1. Alteration of Signal Wiring
2. Lighting Switch
 (Isabella TS, TS de Luxe and Coupé)

Bremen, Germany
 February 2nd, 1959

To all authorized BORGWARD Dealers and Workshops

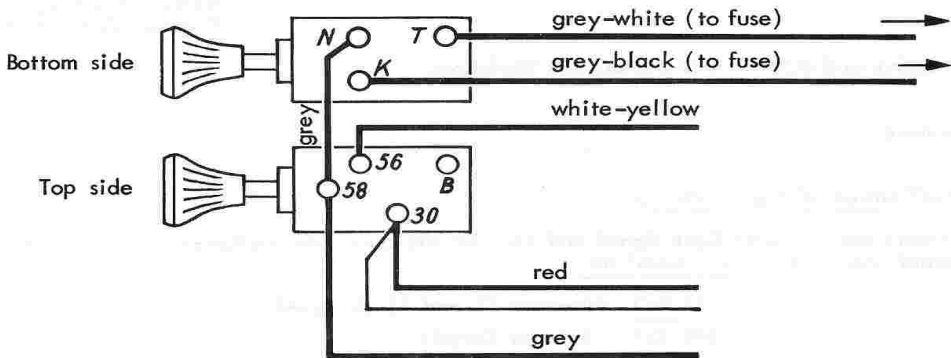
2. Lighting Switch

A new lighting push type switch (part no. 055 514 43 02) is fitted from serial no. 1 132 033 (Isabella TS and TS de Luxe). By this type of switch a simultaneous flashing of the license plate lamp is abolished. (The specification concerning this was cancelled.)

- a) The lighting switch 055 514 43 01 fitted as standard up to serial number 1 132 032 is no longer supplied as spare part. For repairs please use the new lighting switch 055 514 43 02.
- b) When fitting lighting switch 055 514 43 02 in serial no. up to 1 132 032 please proceed according to wiring diagram on reverse page.

Old switch 055 514 43 01 (7 connections)

New switch 055 514 43 02 (4 connections)
